**Economic and Social Council**Distr.: General
11 July 2012

Economic Commission for Europe**Inland Transport Committee****Working Party on Road Traffic Safety****Sixty-fourth session**

Consolidated Resolution on Road Signs and Signals:**Charging points for electric vehicles****Proposed amendments to the Consolidated Resolution on Road Signs and Signals (R.E.2)****Note by the secretariat***

This document has been prepared on the basis of ECE/TRANS/WP.1/2011/2 and ECE/TRANS/WP.1/2011/10 with contributions from the Government of Portugal. Amendments are proposed on paragraphs 1.12, 1.13, Annexes V and VI of the Consolidated Resolution on Road Signs and Signals (ECE/TRANS/WP.1/119/Rev.2). These concern the road signs (F type) indicating the location of fuelling stations selling electricity and additional panels (H type) accompanying E14 (in cases of applicability) and C18 sign (in cases of inapplicability). A number of equally valid alternatives (for both the road sign and additional panel) are proposed (for incorporation into R.E.2) given that consensus was not reached at WP.1, on a unique road sign and additional panel model. This document also proposes additional editorial change

Annex V 5. Electric vehicles

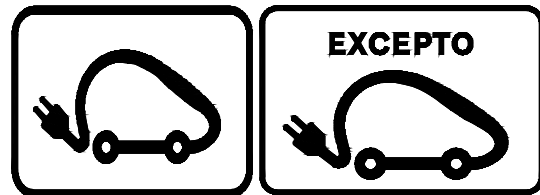
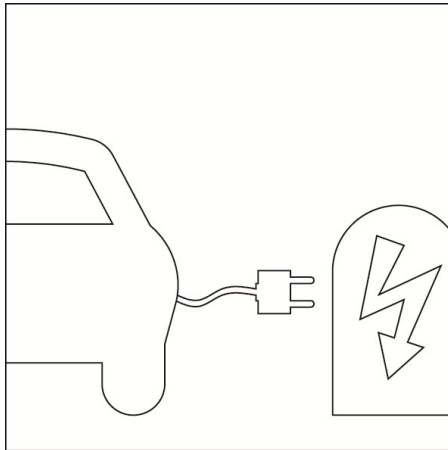
(f) The “Electric vehicles” panels shown in Annex V to this Consolidated Resolution present panels that are recommended to be used with the appropriate roads signs indicating or prohibiting parking.

(Paragraph 1.13 (b))

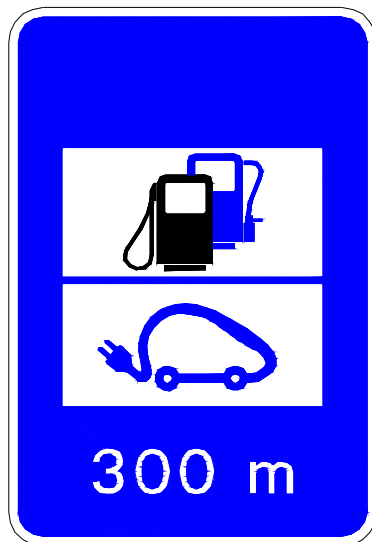
In order to better inform drivers and harmonize, to the extent possible, road signs in use, it is recommended that one of the signs showed in Annex VI (paragraph 1.13 (b)) be used to designate charging points for electric vehicles.

The signs are composed of the "F" sign (as defined in the 1968 Convention on Road Signs and Signals) with the symbol "F,4" inscribed in black or in black and dark blue accompanied by a symbol of an electrical plug in black or dark blue.

The following illustrates the recommended road signs to indicate the locations of refuelling points for electric vehicles (examples from Belgium, Denmark, Portugal and Sweden).
